JOB TITLE:
PROPOSED BLUE SKILLS TRAINING FOR EMPLOYMENT CENTRE (BSTEC) FOR THE KISUMU NATIONAL POLYTECHNIC ON KISUMU MUNICIPALITY / BLOCK 9 / 101

DRAWING TITLE:
SITE PLAN

P-150	DRG. NO: 01	REVISION:	DRAWN BY: J.O.O.
	SCALE: 1:300	DATE: MAR 2026	CHECKED BY: O.M.

NOTES

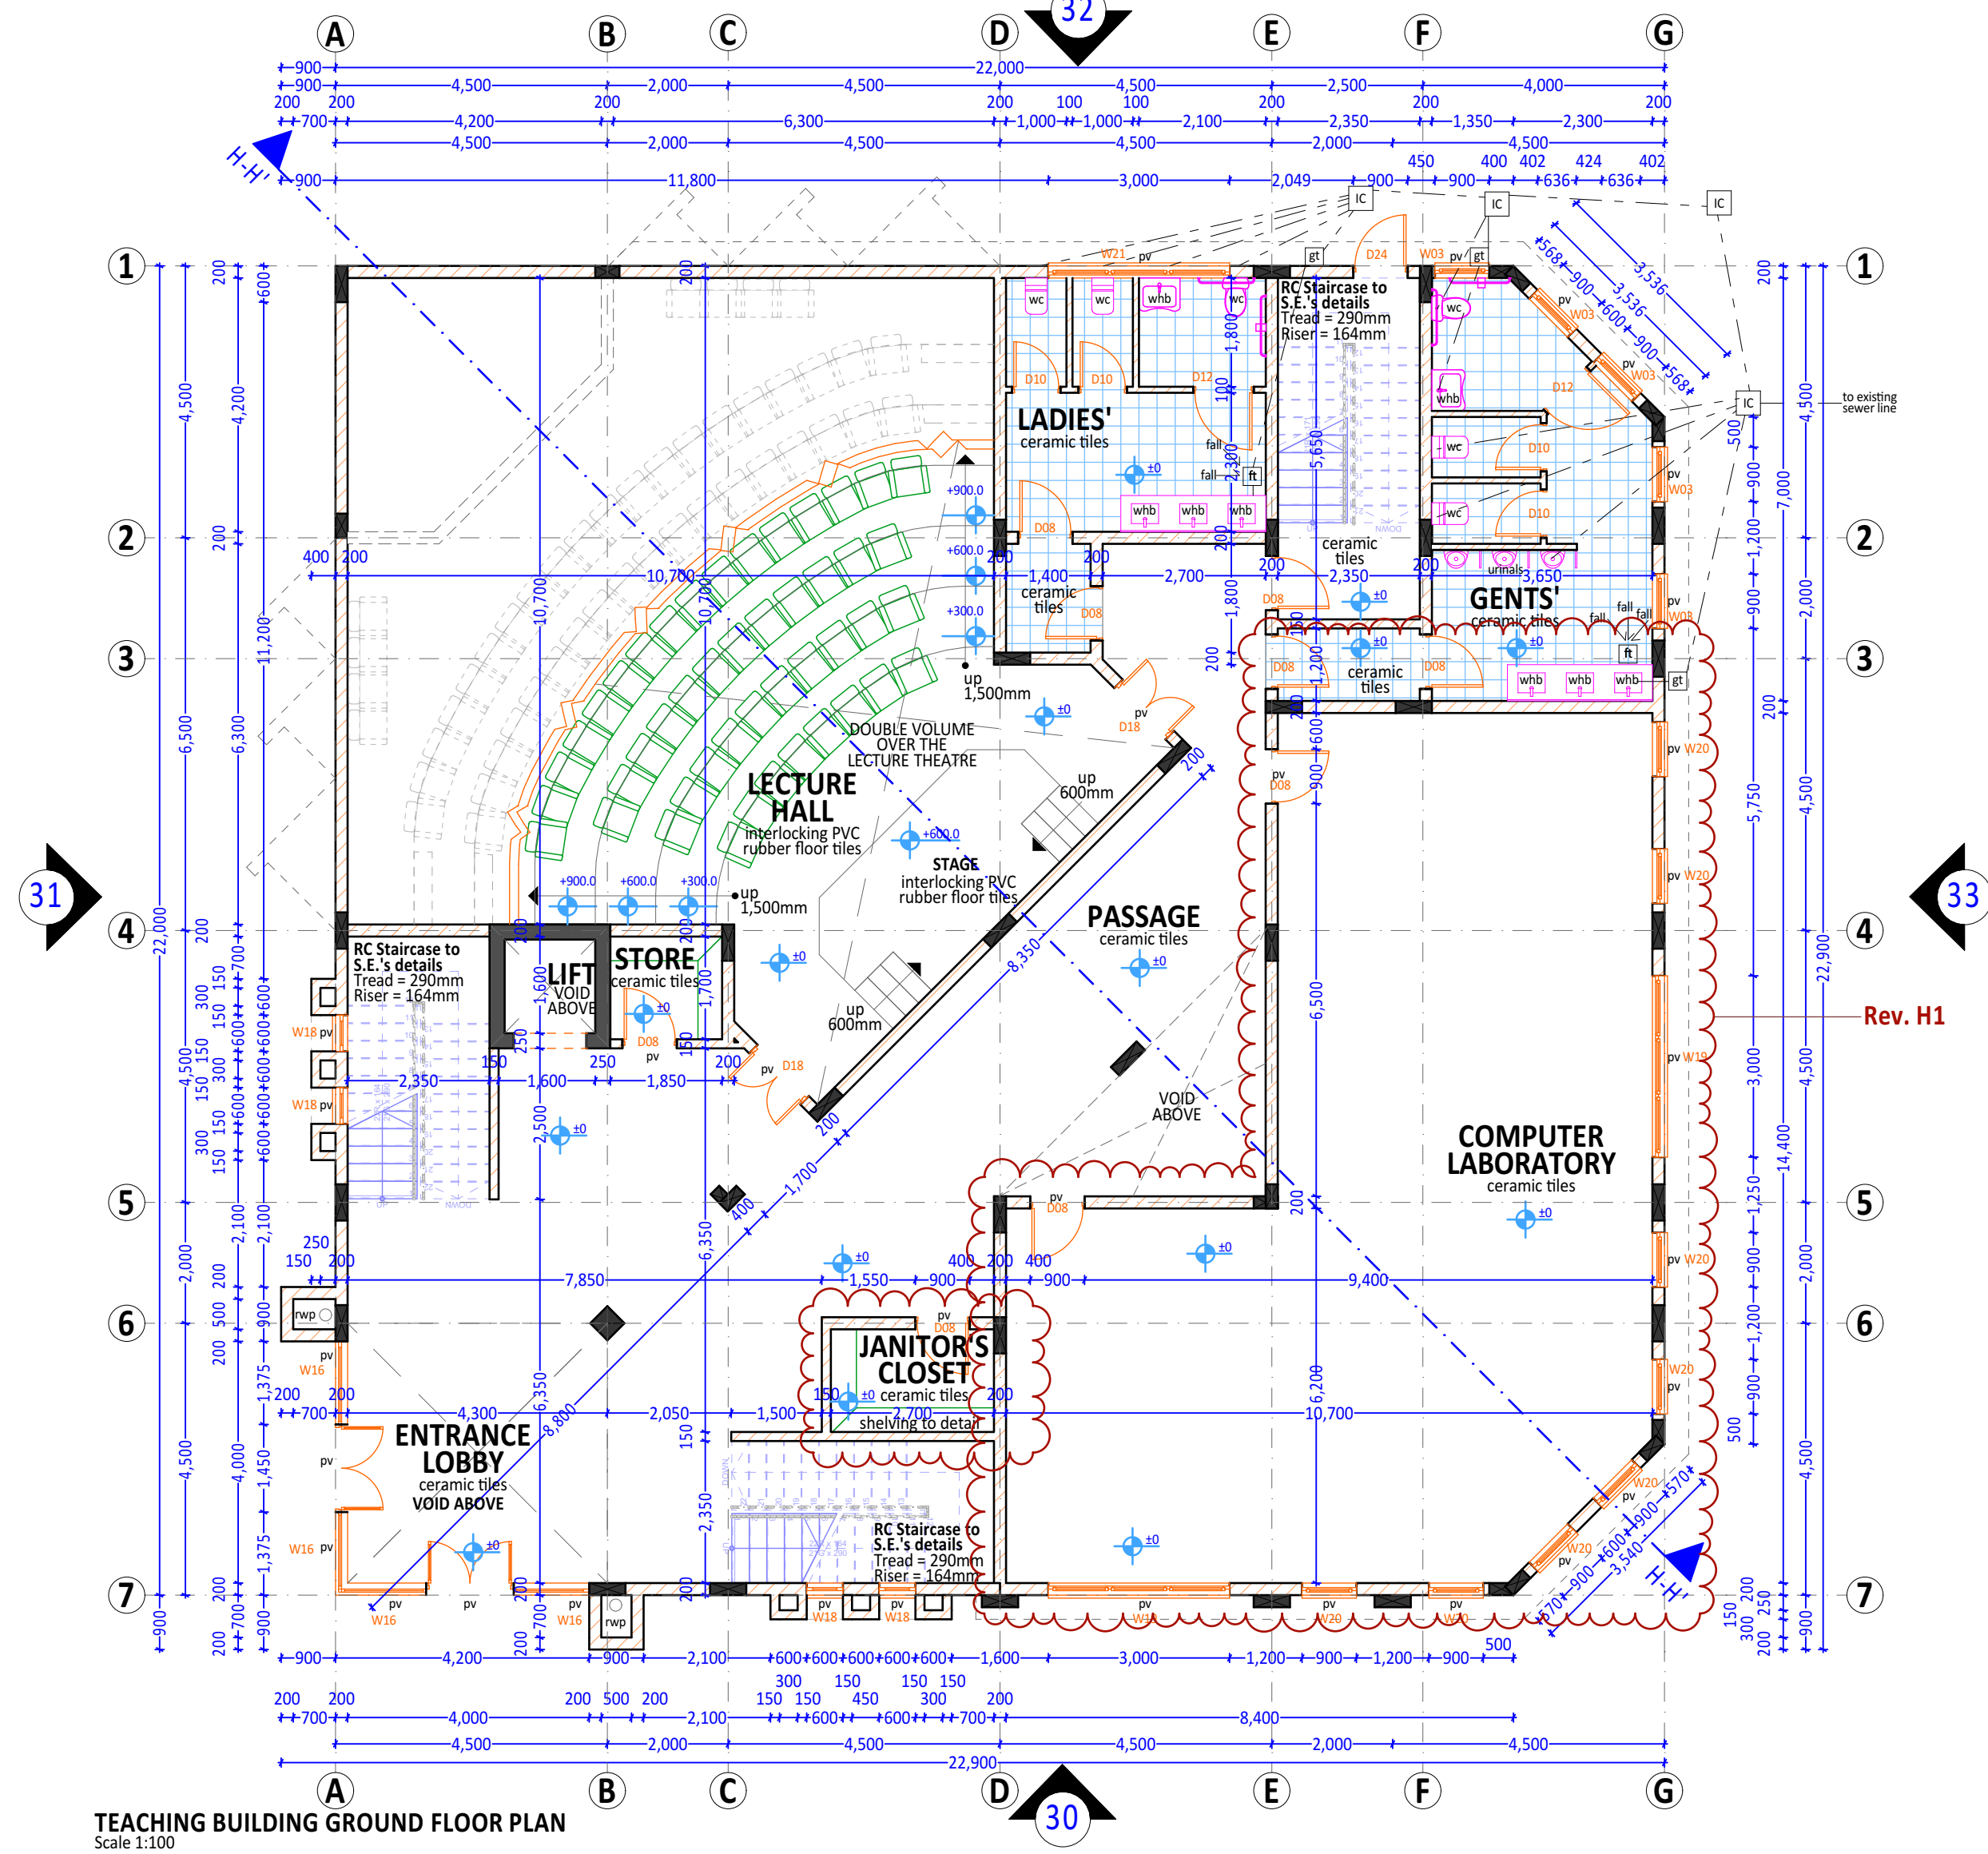
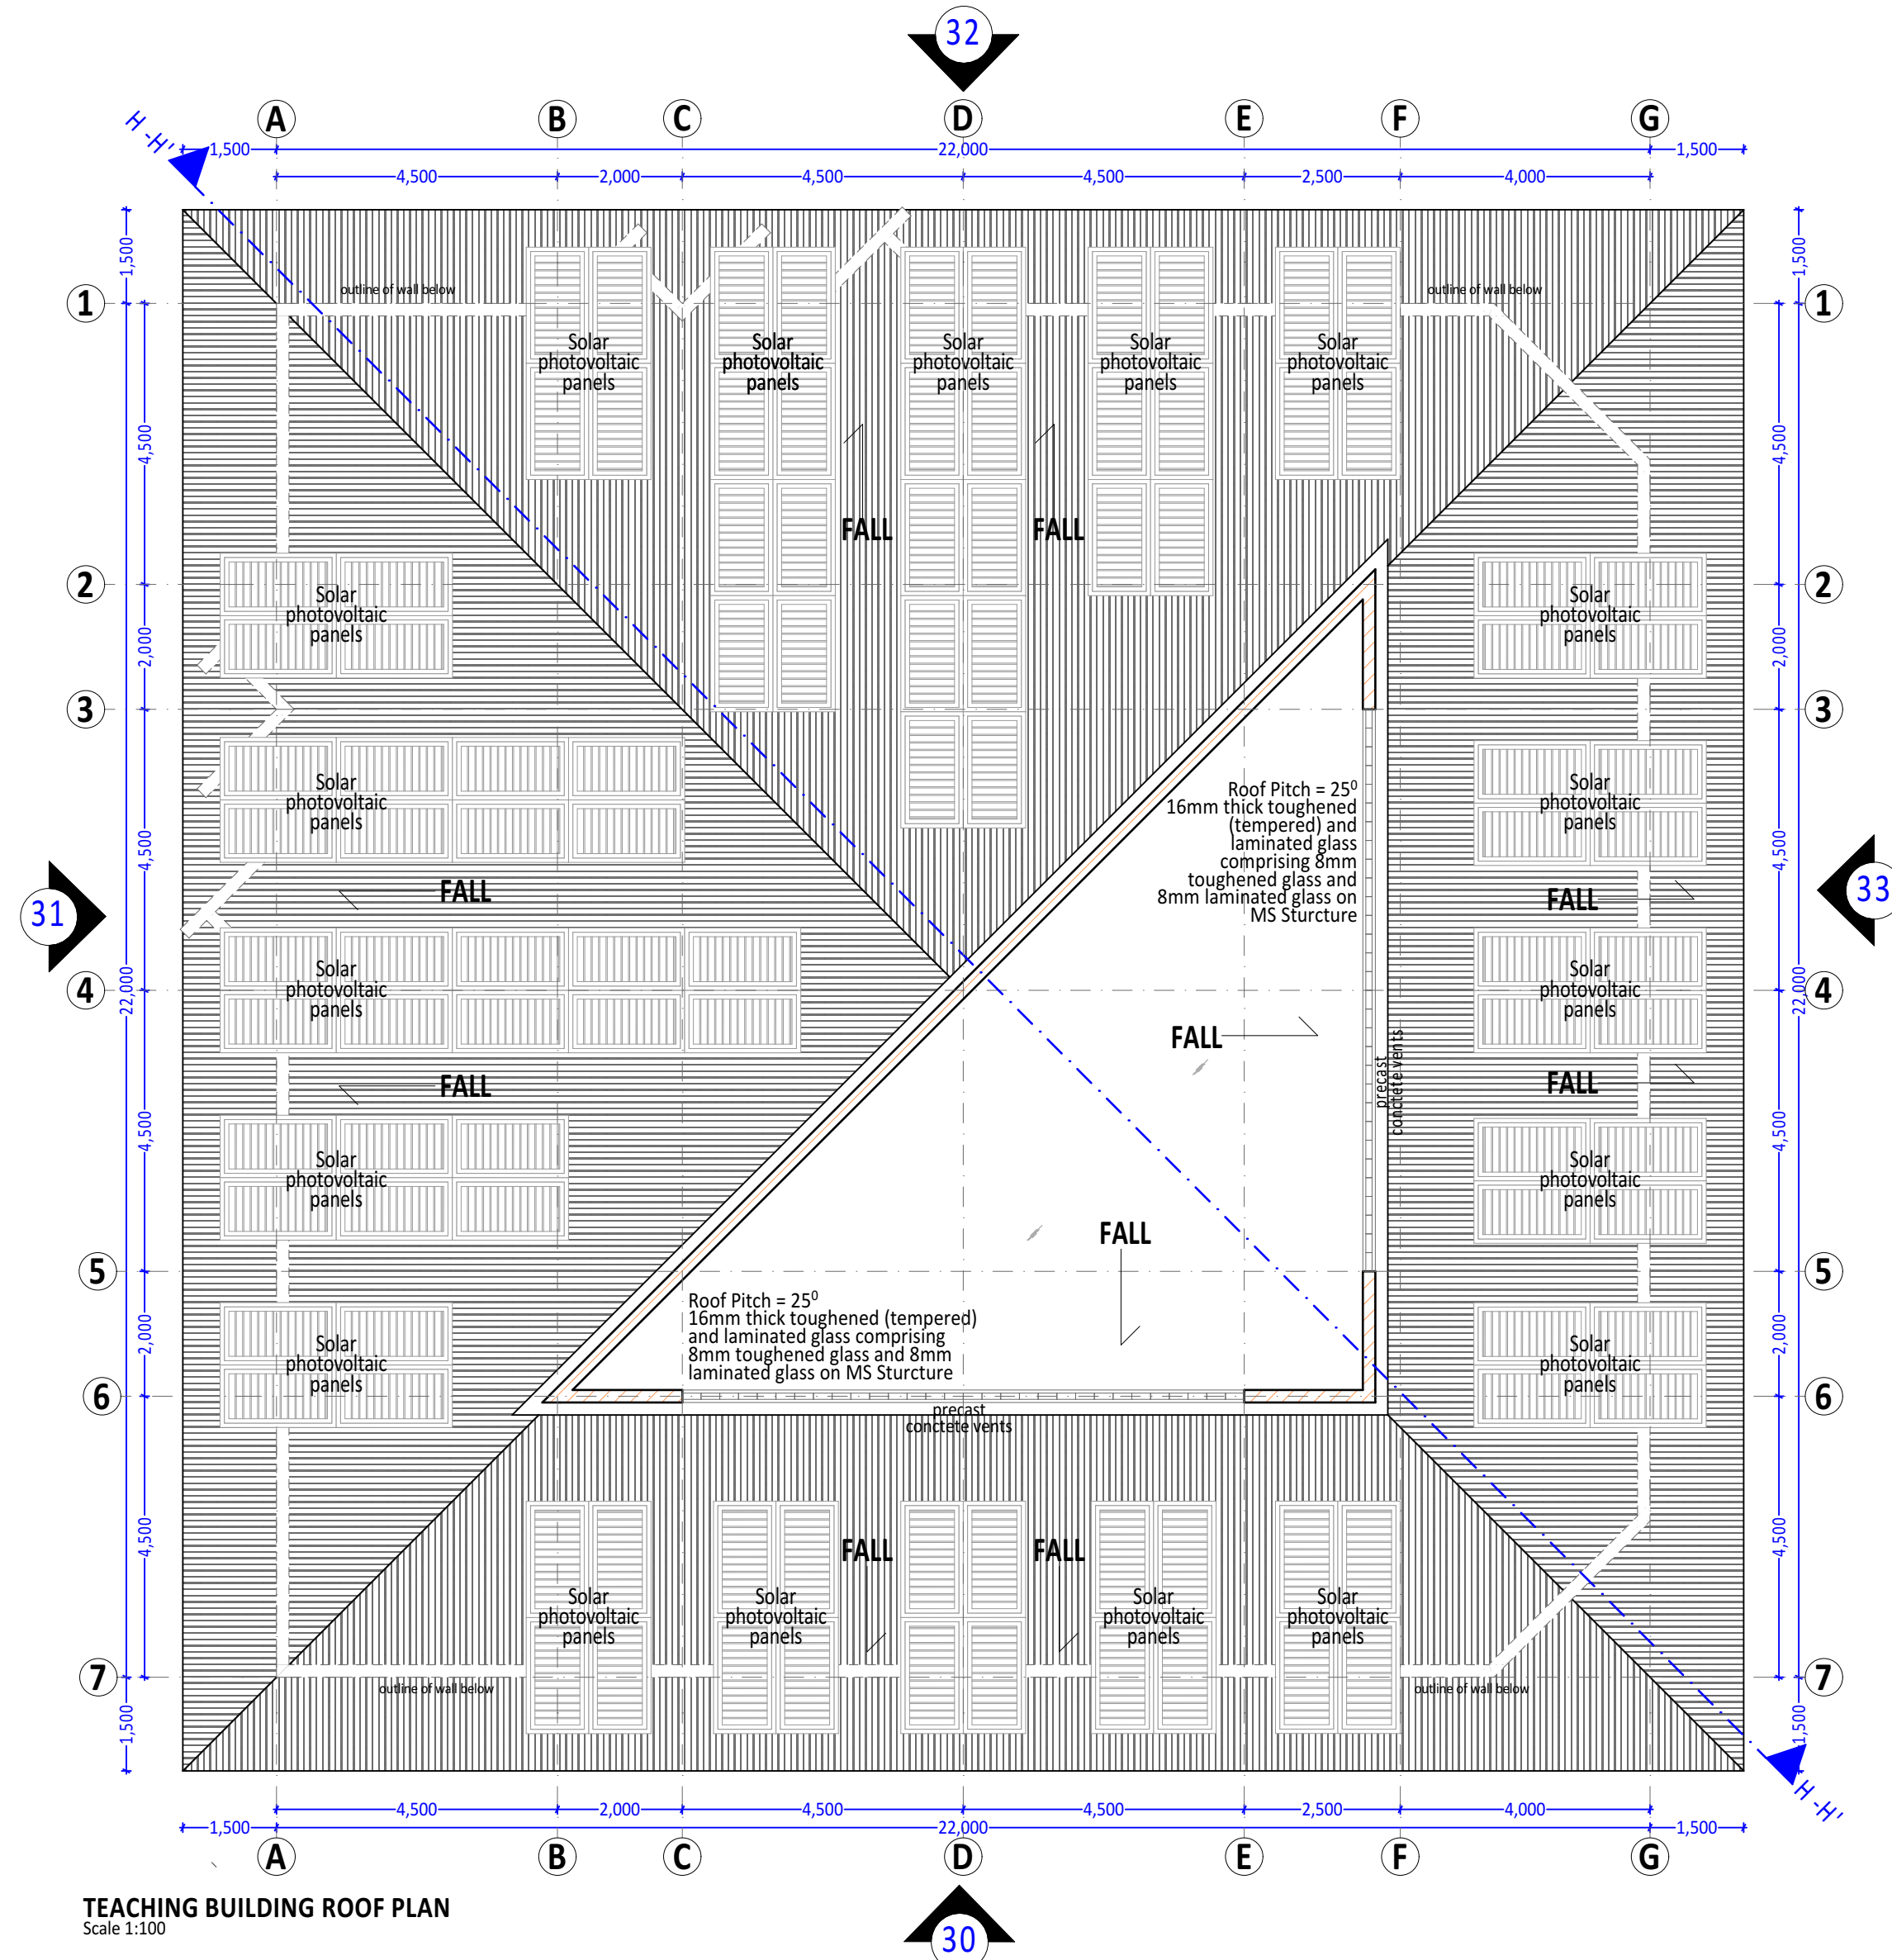
No.	Date	Revision/Issue
Rev. H1	15/06/26	Classrooms have been revised to be a Computer Laboratory of 96m².

TEACHING BUILDING FIRST FLOOR PLAN
Scale 1:100

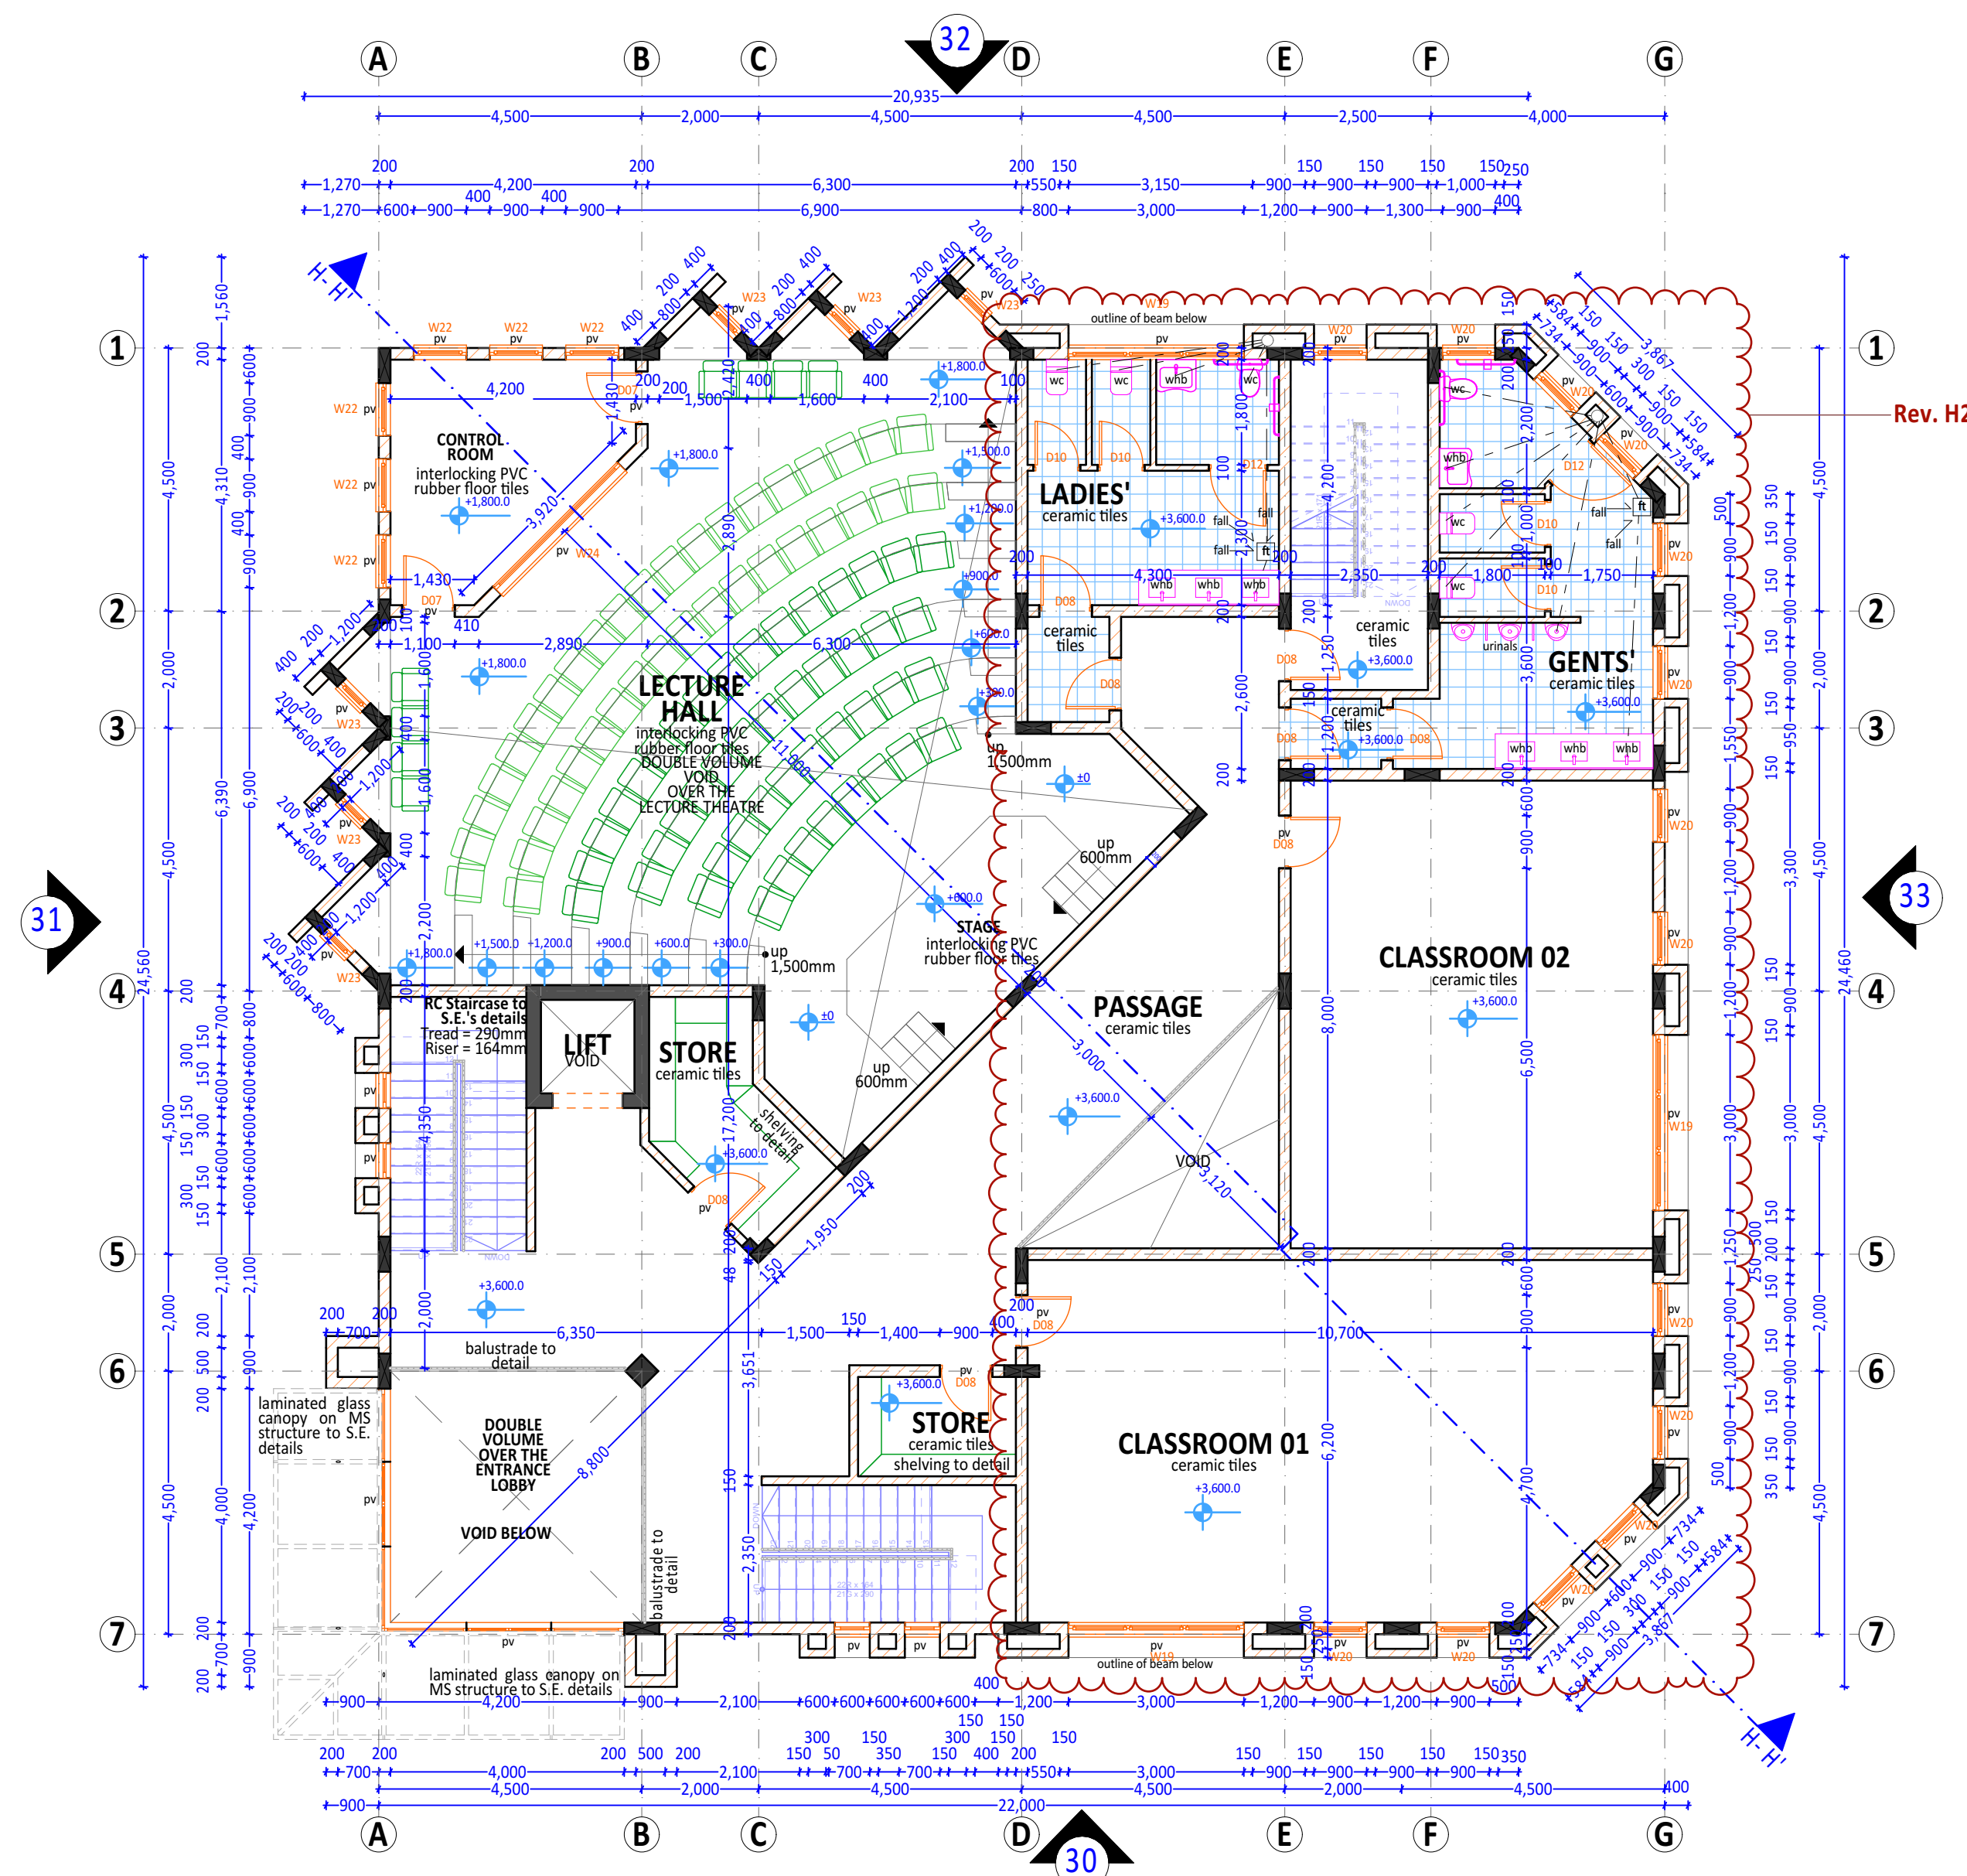
No.	Date	Revision/Issue
Rev. H2	15/06/26	Classrooms number revised from being 6 no. to 3 no. Classroom 01.03 size increased by inclusion of passage that was between G.L.E and F to the classrooms' space
